SRR-CWDA-2021-00086_Draft
Revision 0

ACTION ITEM FOLLOW-UP IN SUPPORT OF U.S. NUCLEAR REGULATORY COMMISSION SALT WASTE DISPOSAL ONSITE OBSERVATION VISIT FROM AUGUST 12, 2021

Figure 1: Approximate Location of Floor Drains

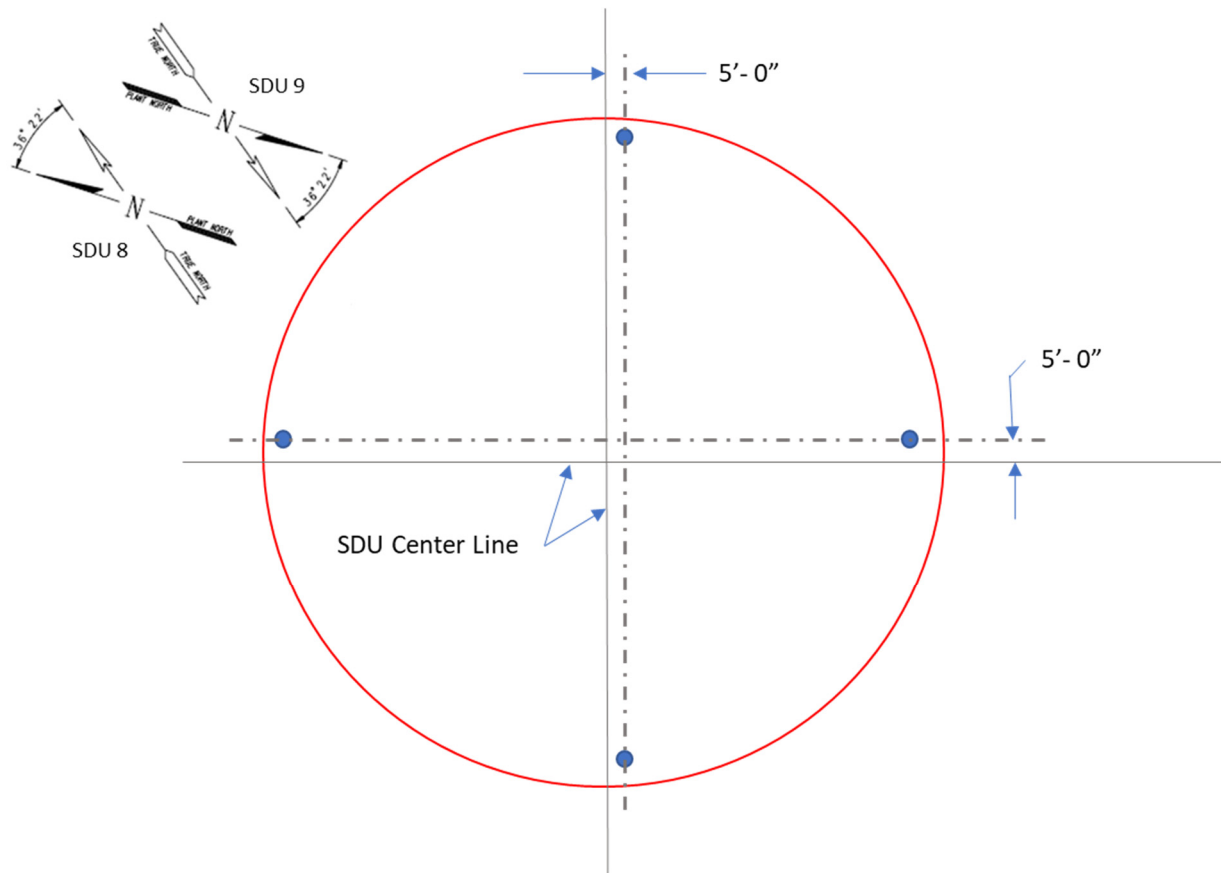
- NRC # SDF-CY21-01-004 (Action Item # 5 from 8/2021 OOV, Reference 1)
 - *The DOE will provide the NRC with a report (or reports) that describe the procedures for and results of the SDS 7 hydrotest.*
- NRC # SDF-CY21-01-005 (Action Item # 6 from 8/2021 OOV, Reference 1)
 - *The DOE will provide the NRC with information on the piping material and quantity of the floor drains being installed in SDS 9 and other 375-ft. disposal structures.*
- NRC # SDF-CY21-01-006 (Action Item # 7 from 8/2021 OOV, Reference 1)
 - *The DOE will provide the NRC information on the change in thickness of the High-Density Polyethylene layer between the LMM and the UMM from 100 mil and the reason for that change.*

The floor drains are installed in each quadrant of the SDU to act as a drain to remove water (e.g., rainwater) during tank construction since the water stops and walls cause ponding on the foundation. Figure 1 provides the approximate locations.
